# COMMUNITY DEVELOPMENT DEPARTMENT REPORT

HEARING DATE: 12/5/2024  
TO: Planning & Zoning Commission  
FROM: Linda Ritter, Associate Planner  
208-884-5533  
lritter@merifiandcity.org

APPLICANT: Dominic Pera, JGT Architecture

SUBJECT: H-2024-0053  
3970 E. Overland Road - AZ

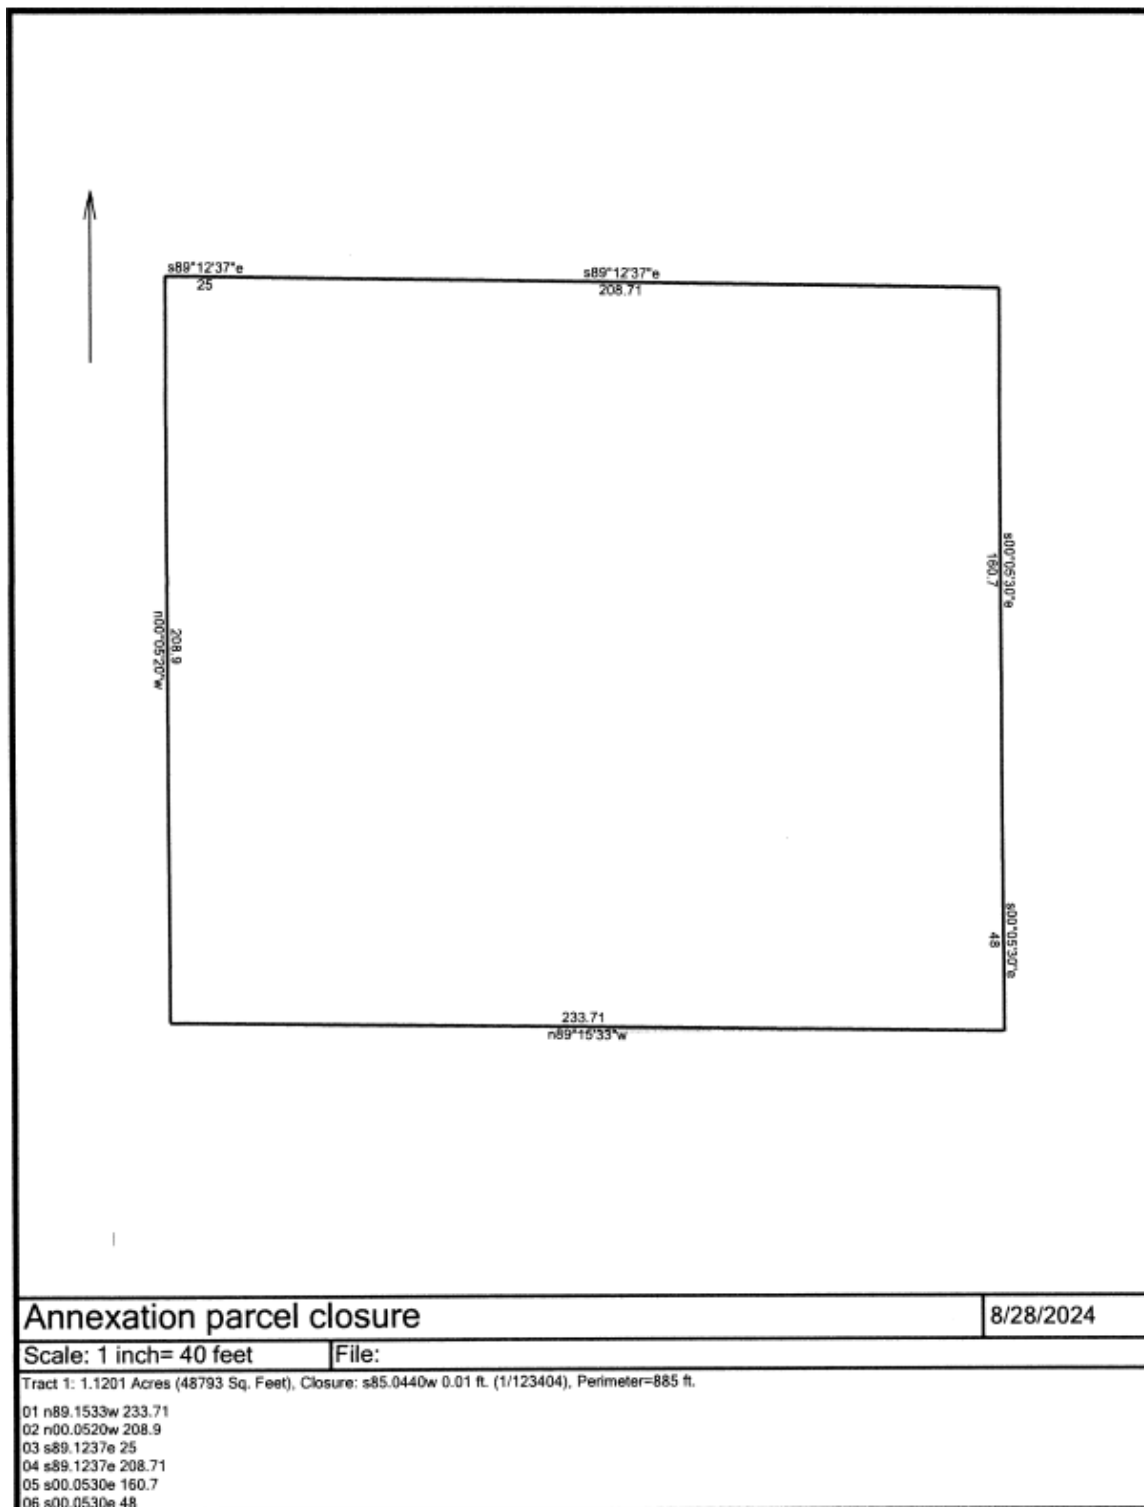
*The single-family residence to the north and the east will be required to be screened with a twenty-five (25) foot landscape buffer and a six (6) foot privacy fence. The applicant is requesting a reduction of the 25-foot landscape buffer adjacent to the residential properties to the north and east. The property is currently in probate therefore staff cannot verify the letter received authorizing the landscape buffer reduction. The applicant has the option of requesting permission from the probate court or requesting a waiver to reduce their landscape buffers. The applicant is requesting a Council waiver to reduce the landscape buffer to the residential use down to fifteen (15) feet.*

*The applicant is proposing to install a six (6) foot high vinyl fence along the northern property line. The applicant will need to provide fencing on the residential portion on the east side of the property. Fencing shall comply with the requirements outlined in UDC 11-3A-7.*

- b. Direct access to E. Overland Road is prohibited.
- c. Provide a 25-foot landscape buffer to the north and east along the north side of the property along with a six (6) foot privacy fence to block headlines from the residential property unless waived by Council.
